STAFF REPORT: 10/12/2022 REGULAR MEETING PREPARED BY: J. ROSS

ADDRESS: 1424 IROQUOIS **APPLICATION NO:** #2022-8053

SCOPE: REPLACE PORCH DECK

1424 Iroquois. Note that expansion joints are marked by small square pieces of marble.

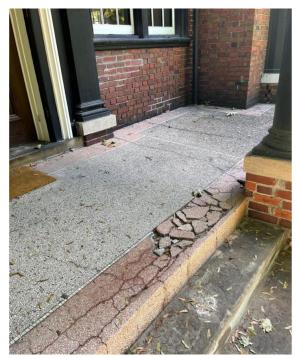
• The expansion joints at the terrazzo porch floor at 1424 Iroquois are marked by cubes of marble. No metal strips are visible at the porch. It is staff's opinion that the flooring was likely installed prior to 1924 as the cubed marble expansion joints date from the time prior to the introduction of metal strip dividers/expansion joints
